23001-033 -> 23000-203:

b) Connector Positions (black: 23001-033, red: 23000-203):

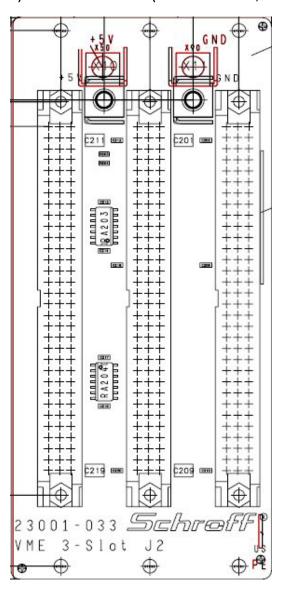
a) Backplane Dimensions:

23001-033			23000-203		
Width [mm]	Height [mm]	Thickness [mm]	Width [mm]	Height [mm]	Thickness [mm]
59,52	128.50	3.20	60,73	129,99	3.20

- 1) PE faston removed
- 2) Position of power bugs moved by 10.16mm to the bottom. Sequence changed for optimal power distribution.
